**ADDENDUM
NO. 1**

October 28, 2022

**LIBERTY ELEMENTARY SCHOOL RENOVATIONS
Chesterton, IN 46304**

This Addendum consists of Pages ADD 1-1 and attached Addendum No. 1 from Gibraltar Design dated October 26, 2022 and consisting of 4 pages, Hardware Set 17, and 23 Drawings.

GIBRALTAR DESIGN SHEET
B P-112

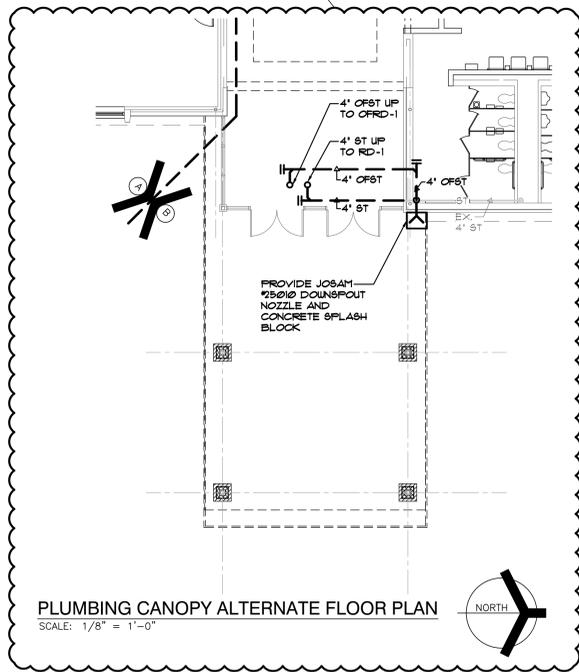
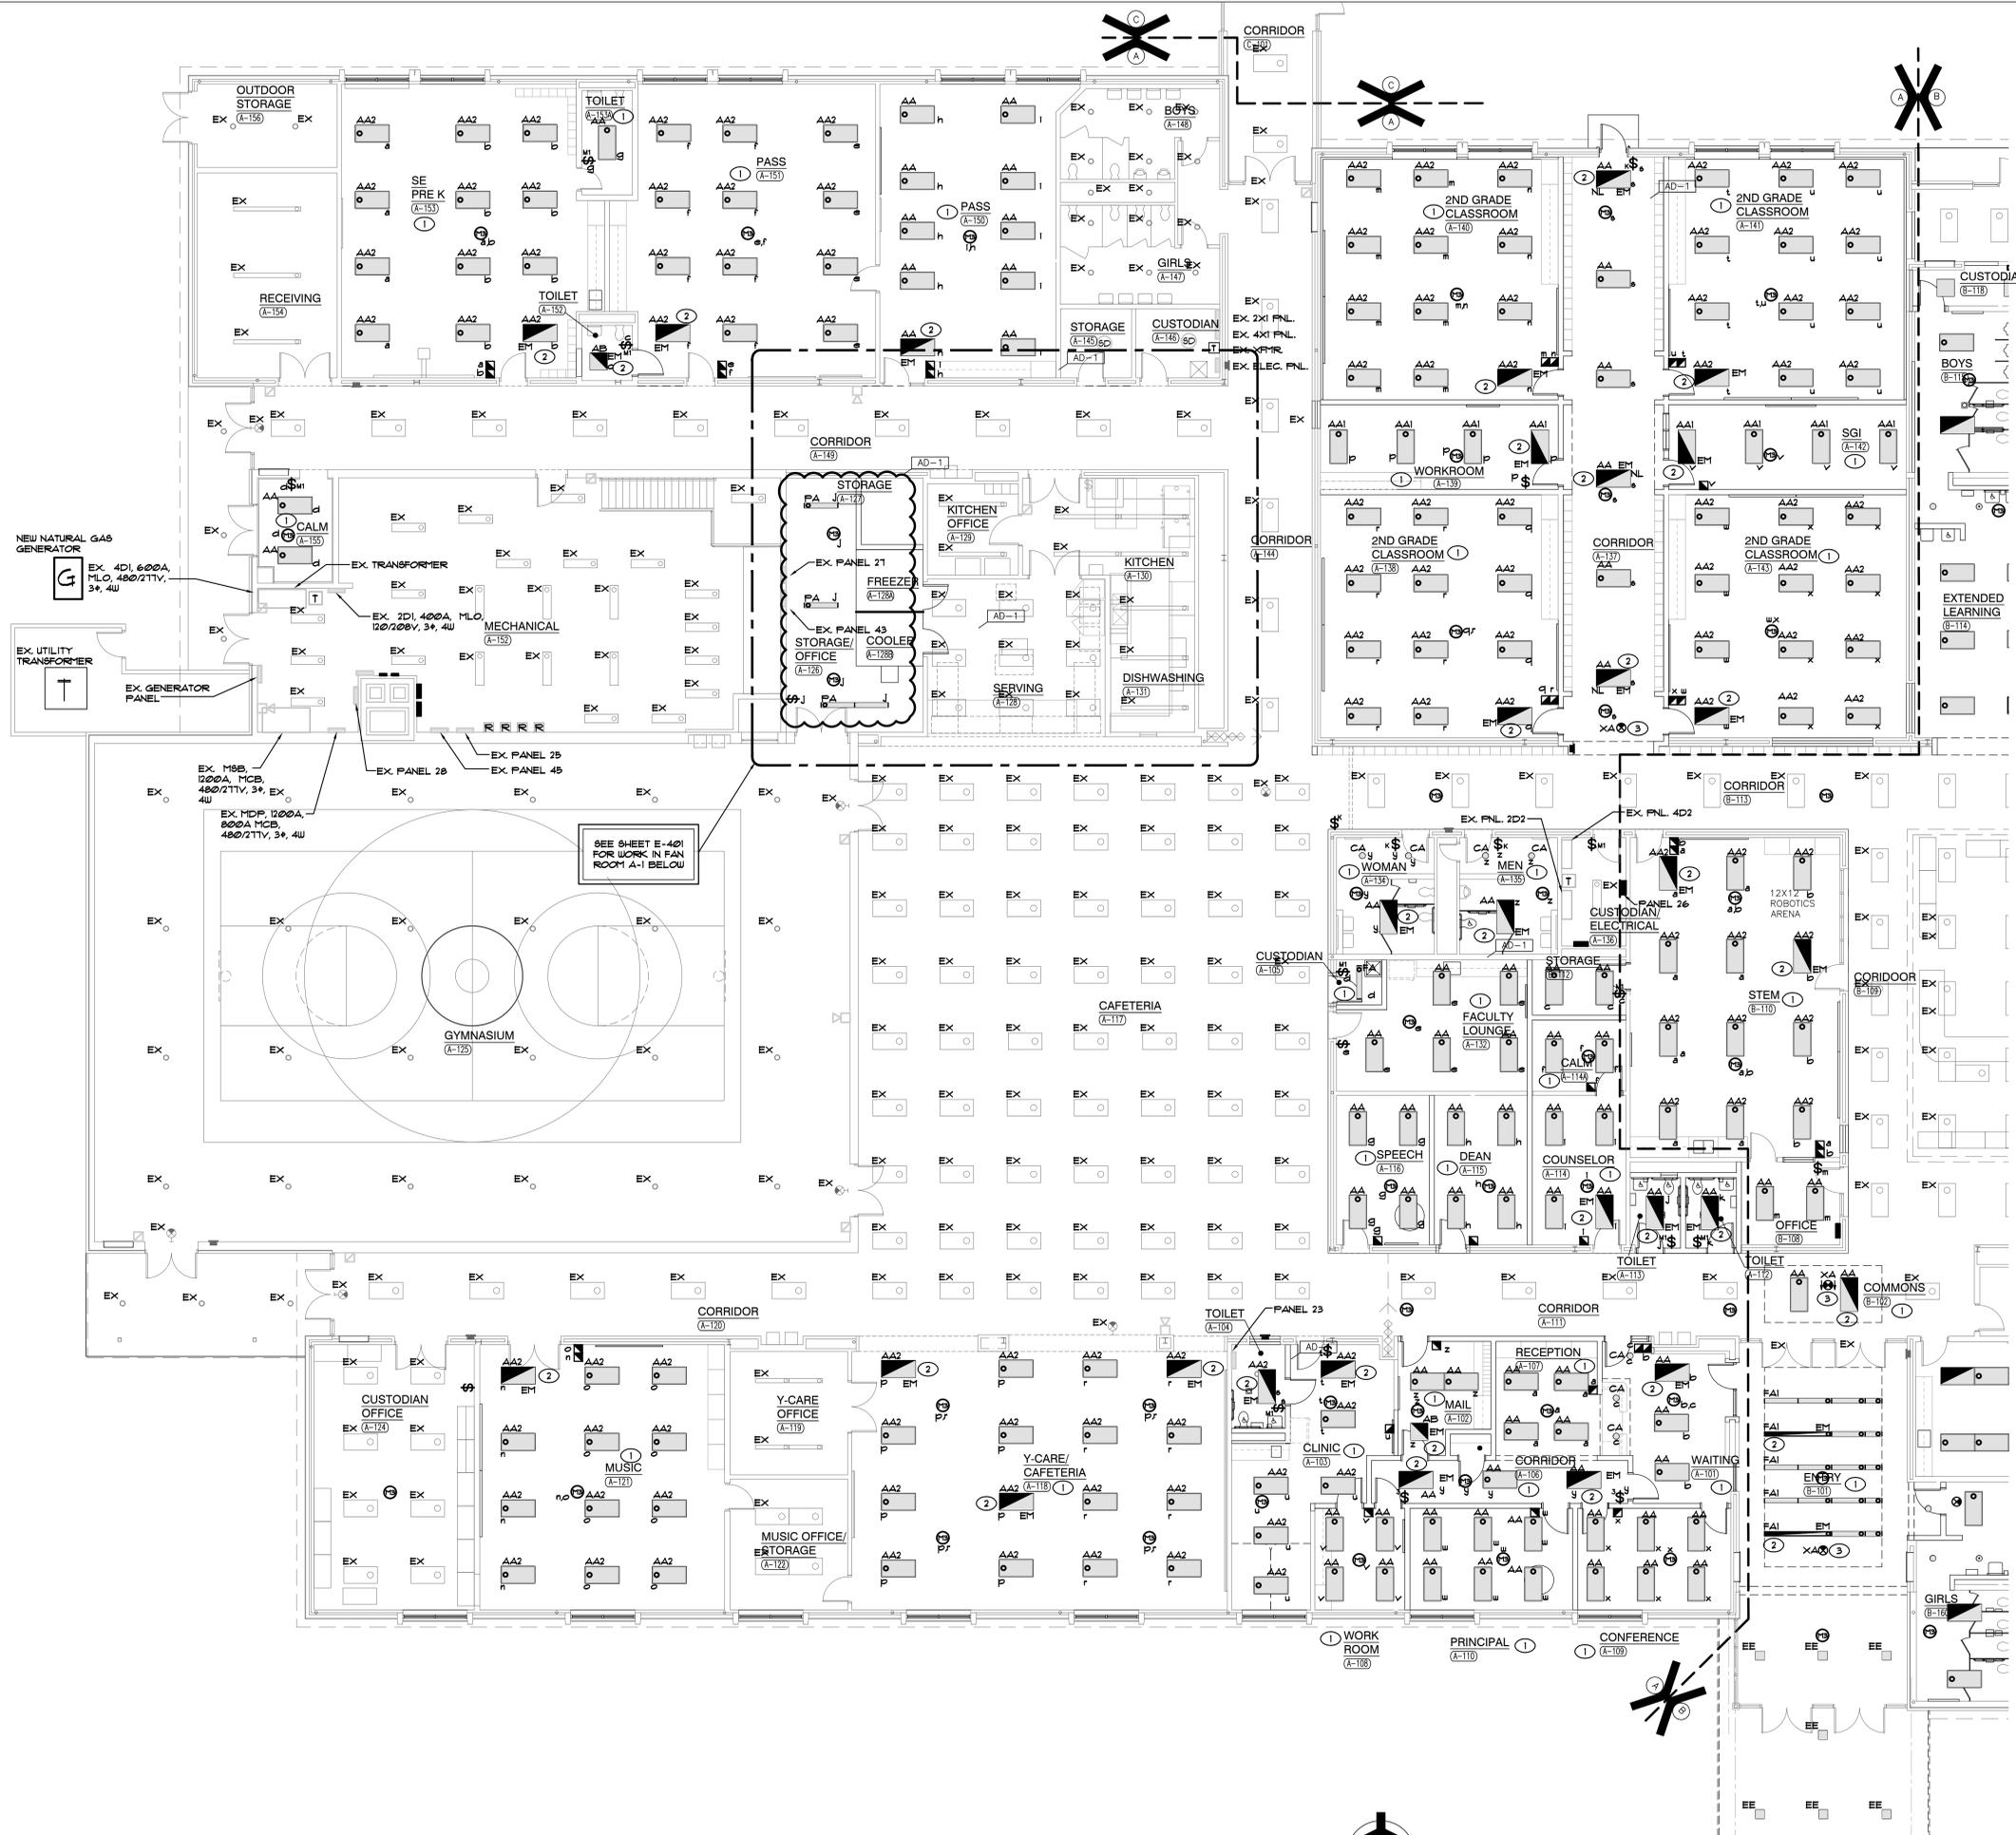
14. Sheet PD102 and P-112

- A. Refer to two revised full size drawings, included in this Addendum, for canopy alternate.
